PLANNING REPORT

Planning and Zoning Commission

Thursday, August 18, 2022

Amlin Crossing 22-043CP

Southwest Area Plan (Avery West detail) map with general project location and Tuttle Crossing Boulevard indicated

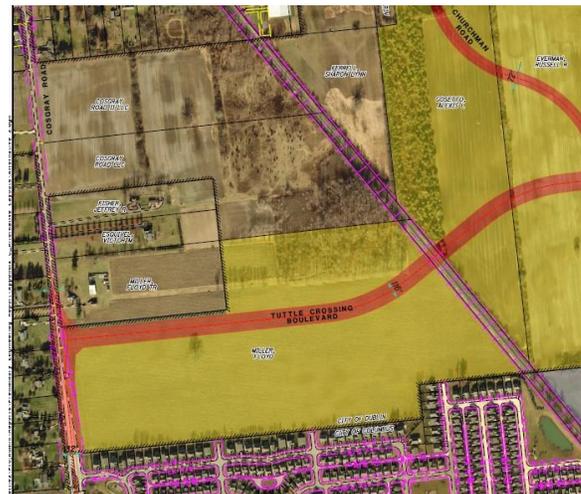
The Southwest Area Plan (Avery West Detail map) shows specific design recommendations that should be considered with the proposed development. Evaluation comments are italicized:

- A 200-foot setback along the railroad (east boundary of project site), *recent Dublin developments have utilized a 100-foot setback;*
- A minimum 200-foot setback along Tuttle Crossing Boulevard, *based on the new road alignment, this would take a large portion of the southern portion of the property;*

- Gateway feature for the Village of Amlin (dark red on map below left), *still applicable;*
- The Mixed Use Village Center extending south from Rings Road onto Cosgray Road, some of which would be on this site (dark red on below left map), *still applicable;*

- Mixed Residential Medium Density south of Amlin and wrapping southeast (5 du/ac) (brown on below left map), *still applicable;*
- Medium Density Residential on a street/alley system in the heart of this site (1 -2 du/ac) (yellow on below left map), *still applicable, the roadway details will need to be revised to align with City Council's policy regarding public streets;*

- Mixed Residential Medium Density along Cosgray Road (5 du/ac) (brown on map and on remnant parcels below left map), *still applicable;*
- Mixed Residential Rural Density along the border with the City of Columbus to the south (1.5 du/ac) (light green on below left map), *the applicant debates that the density of the Columbus development to the south makes any low density area undesirable;* and

- The remainder of the site is shown as open space, especially along the railroad, the woodlot, and along most of Tuttle Crossing Boulevard (compare both maps below), *still applicable.*
